NORTH MACADAM DISTRICT STREET PLAN IMPLEMENTATION AMENDMENTS

Ordinance No. 171522

**Amendments to: the Zoning Code, Willamette
Greenway Plan, and the Design Guidelines for the
North Macadam District of the Central City Plan**

Map 510-1 Central City Plan District and Subdistricts

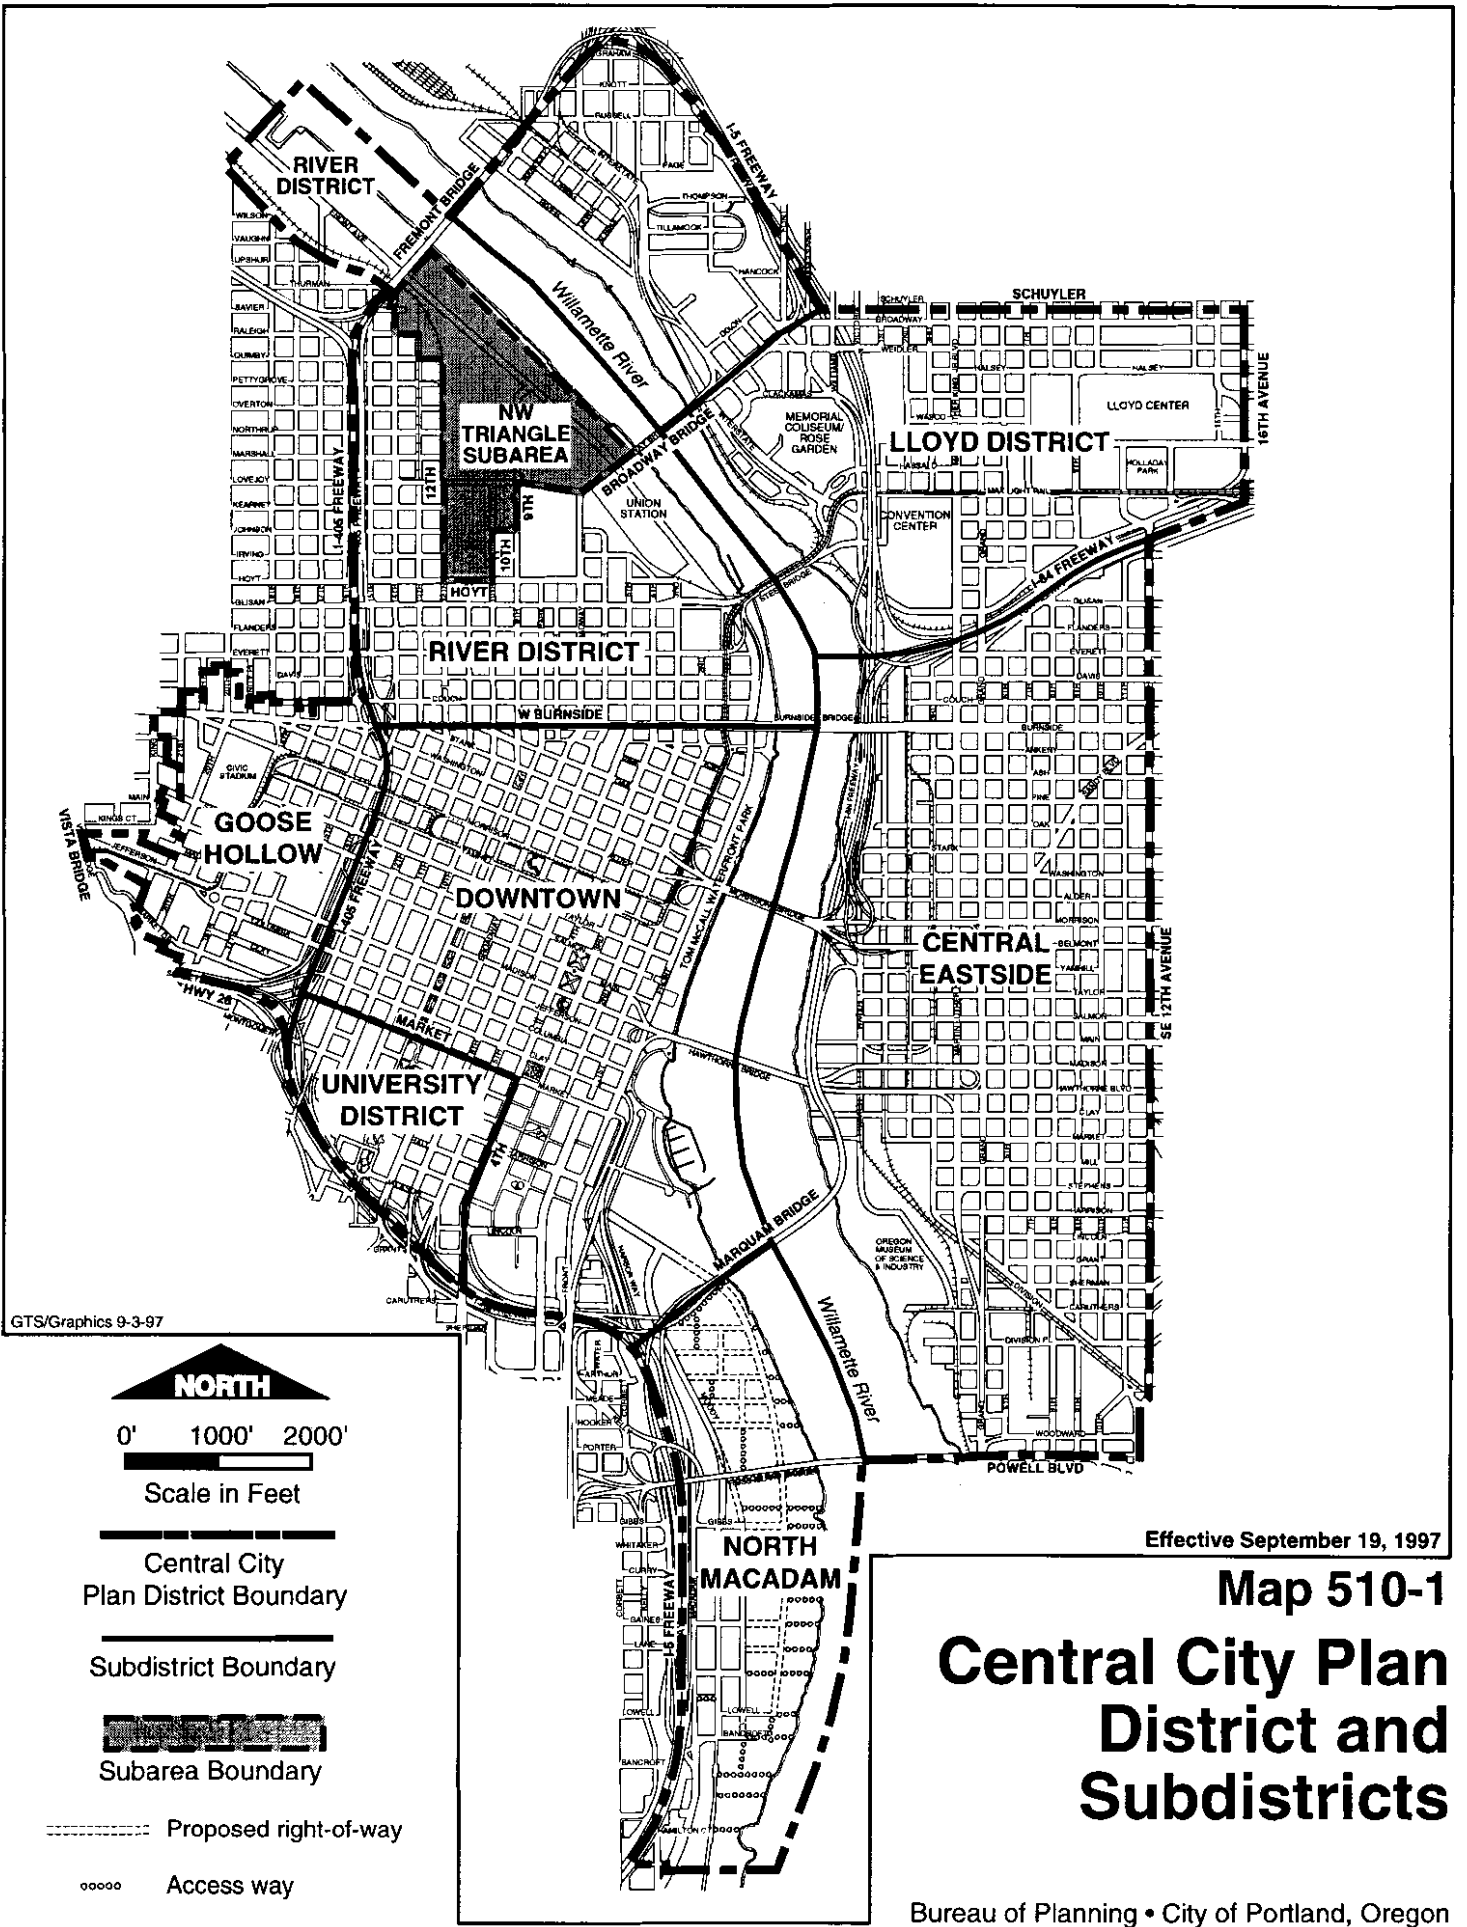
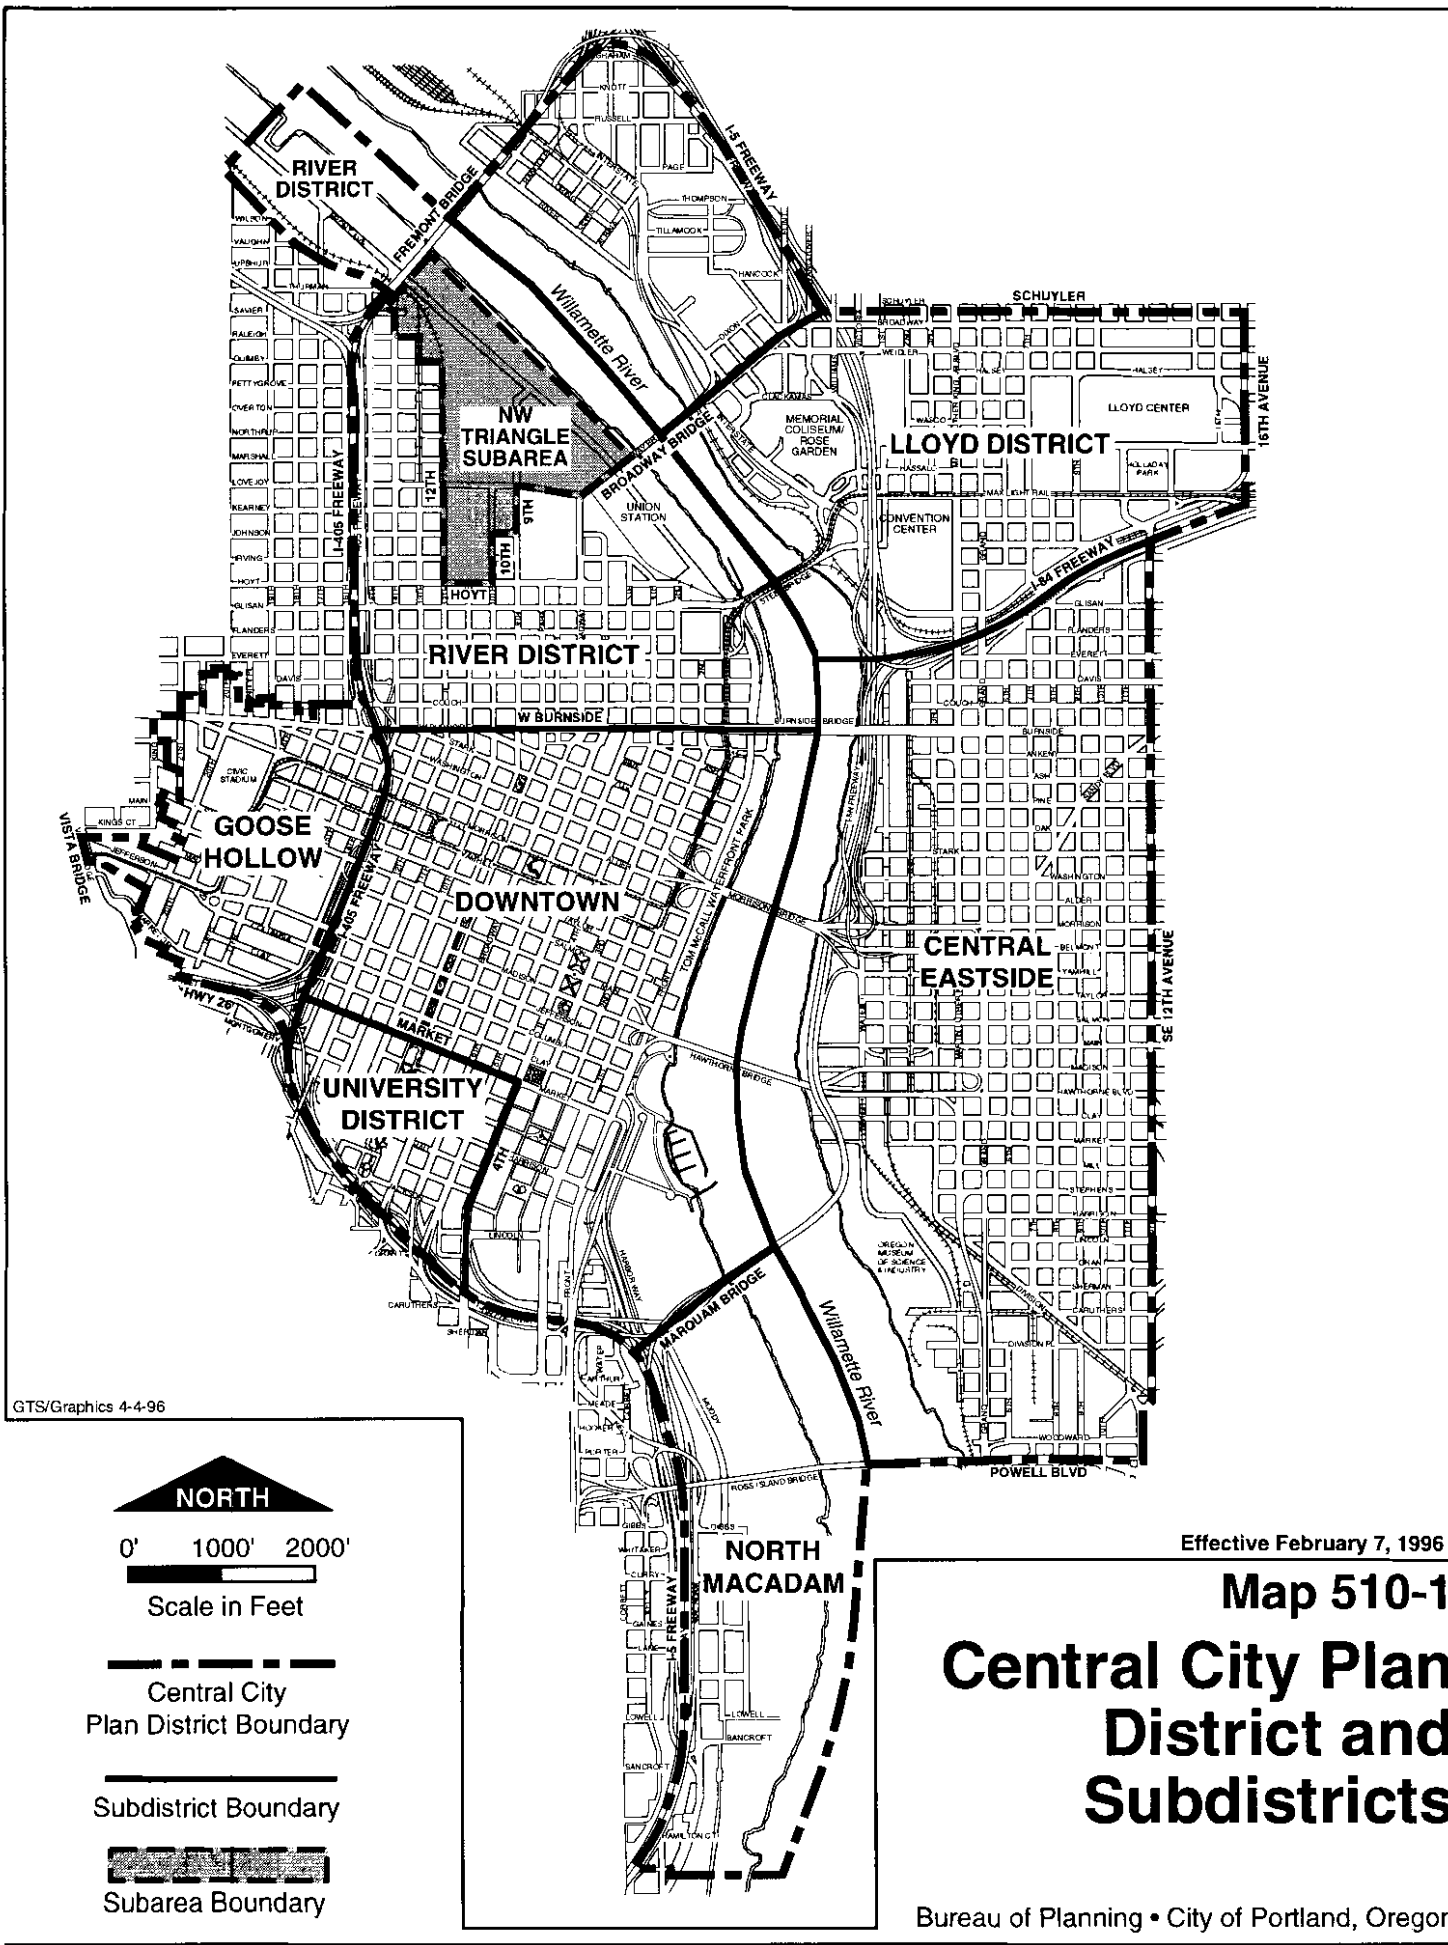
The North Macadam District Street Plan identifies north-south and east-west street rights-of-way and accessways to complete the district's multi-modal transportation network. All of the south segment Central City Plan District maps found in Chapter 33.510 of the Zoning Code, are updated to show the underlying street network including accessways from the accepted district street plan. Street rights-of-way and accessways are denoted differently on the base map than existing streets.

Maps 510-1 through 510-9 are updated to show the new street pattern of the district street plan. Further revisions of Maps 510-2 through 510-4, 510-6, 510-7 and 510-9 are revised and discussed later in this report.

Map 510-2 Maximum Floor Area

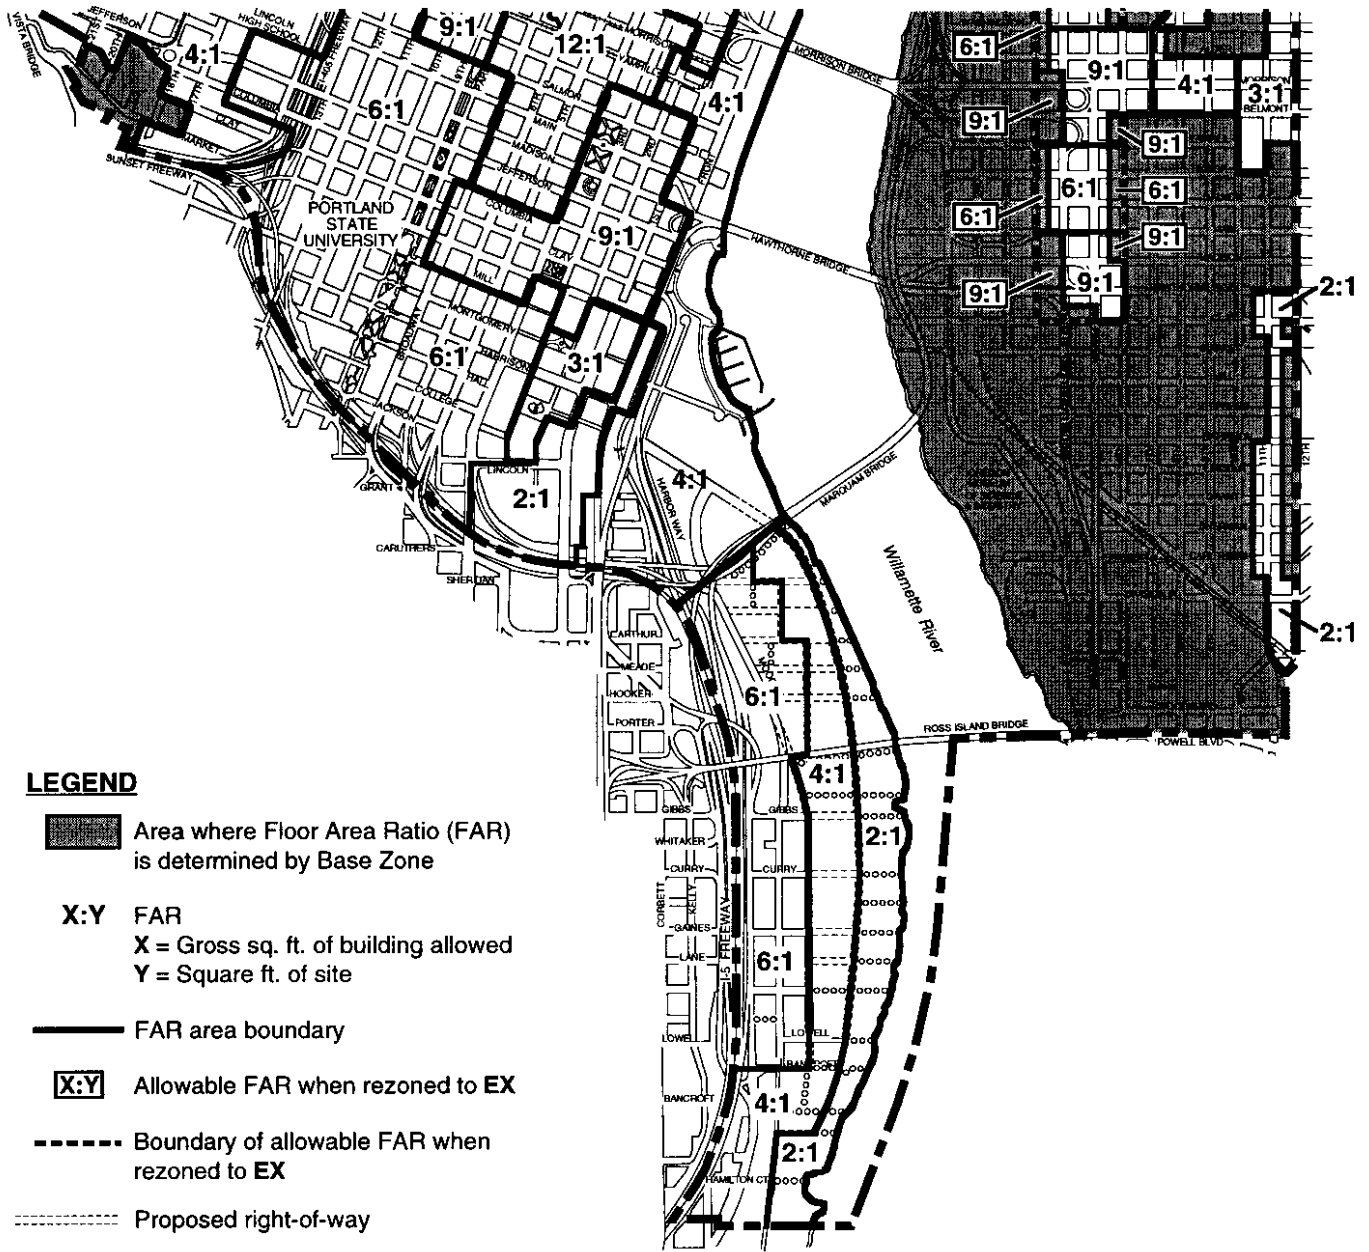
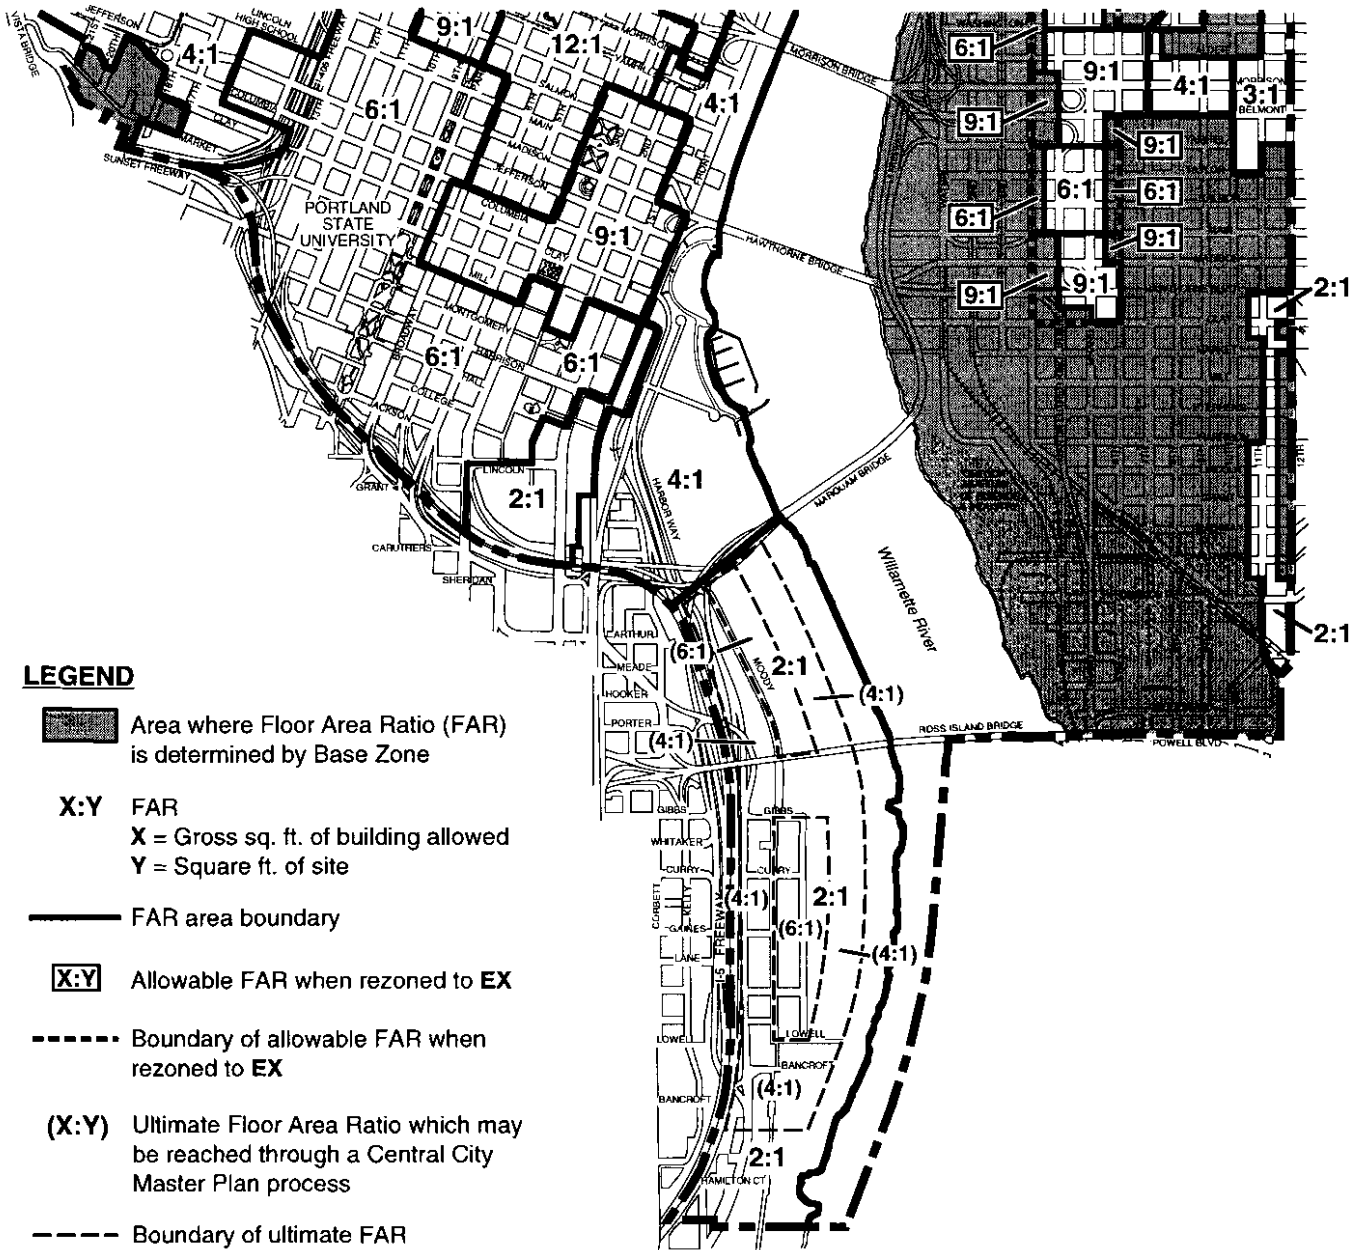
Staff evaluated the existing Maximum Floor Area Ratio (FAR) boundaries (Zoning Code Map 510-2) with the new planned street network for the district, and two related issues were considered. One was the relationship between the current FAR boundary lines and the existing and future rights-of-way. The FAR boundary lines are adjusted to use the centerlines of the streets.

The results of this review are that additional FAR can be provided to mitigate the impacts of street plan implementation in the North Macadam district. See Appendix 2 for Analysis of Development Potential. This will be accomplished by deleting the ultimate floor area ratio and maximum height master plan requirements and by furthering a step-down approach to intensity, delineated by the street plan rights-of-way centerlines. Section 33.510.255 of the Zoning Code details the Central City Master Plan requirements.

The ultimate FARs are now recognized as maximum FARs, which are subject to the previously mentioned regulations, guidelines and review process. The maximum FAR boundary areas are modified to correspond to the new street network. A property owner in the district could still seek approval through a master plan process but it would not be required to reach the maximum FAR and building height for that property.

The revised Map 510-2 (and 510-3) demonstrates the approach to intensity of stepping-down in scale from Interstate-5, east to the Willamette River Greenway. This approach implements the goals, objectives and policies of the Special Design Guidelines of the North Macadam District and the Central City Plan. It is also supportive of the future South-North Light Rail Transit line which may locate along SW Moody Avenue in the district.
